PRODUCT CHANGE NOTIFICATION (PCN)

AMJE0909-0050-GYB-24
MODULAR CABLE

CHANGE NOTIFICATION: PCN 20220509_AMJE0909-0050-GYB-24

DESCRIPTION OF CHANGES:
CHANGE OF DATA SHEET
CHANGE OF DATA SHEET
New Draw.-No. ASS_7945_CArev02

AMJE0909-0050-GYB-24 OLD VERSION

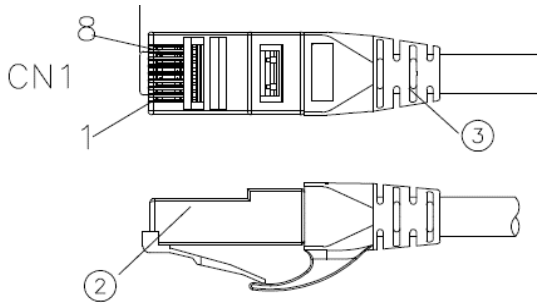
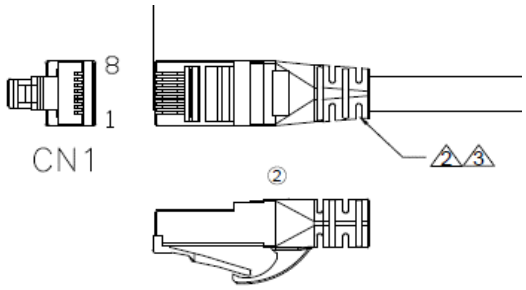
③	Molding	PVC 45P Color: see order code	NA	KG
②	CONNECTOR	RJ45 8P8C two fork Short type 3u" gold plated	2	PCS
①	CABLE	CAT6 UTP (24AWG*1PR)*4+PVC OD=5.8±0.3MM Color: see order code	NA	MM
NO:	NAME	DESCRIPTION	Q'TY	UNIT

3	Molding	PVC 65P Color: see order code ②	NA	KG
2	CONNECTOR	RJ45 8P8C PLUG 3u" gold plated ②	2	PCS
1	CABLE	CAT6 U/UTP (24AWG*1PR)*4+Cross+PVC Jacket OD=5.8± 0.3MM Color: see order code ②	NA	MM
NO:	NAME	DESCRIPTION	Q'TY	UNIT

Drawing-No.
ASS 7945 CA

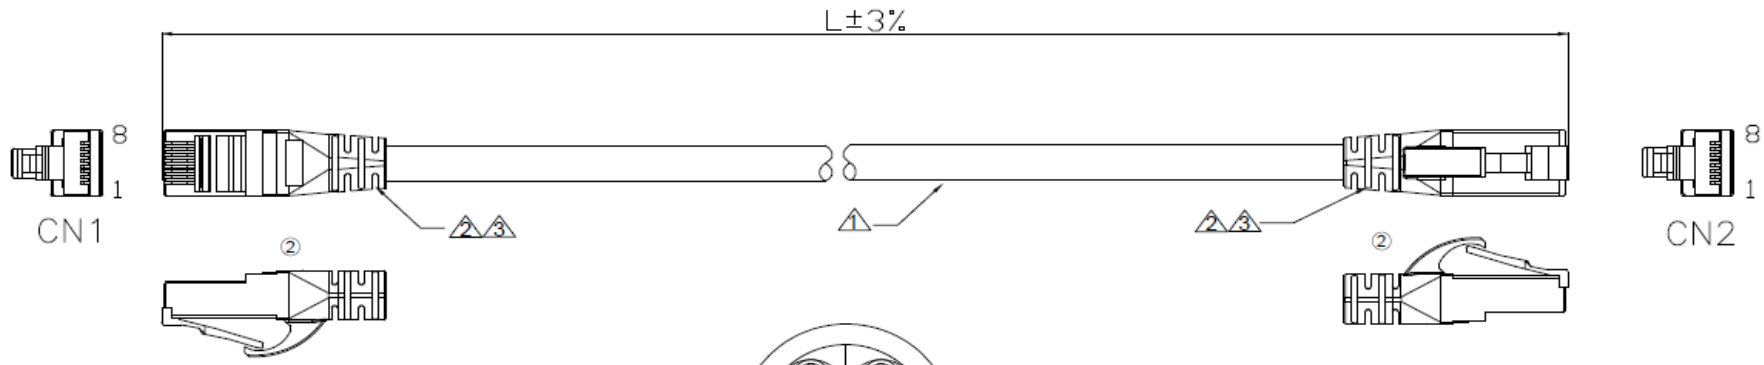
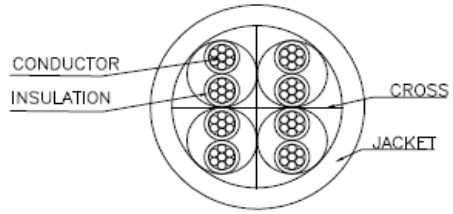
Id.	Modification	Date	Name
②	Change the plant	09.05.2022	Luca
①	Update the WSW order code	02.06.2017	Amy
⓪	Drawn	30.03.2017	Amy

NO:	NAME	DESCRIPTION	Q'TY	UNIT
3	Molding	PVC 65P Color: see order code ②	NA	KG
2	CONNECTOR	RJ45 8P8C PLUG 3u" gold plated ②	2	PCS
1	CABLE	CAT6 U/UTP (24AWG*1PR)*4+Cross+PVC Jacket OD=5.8± 0.3MM Color: see order code ②	NA	MM
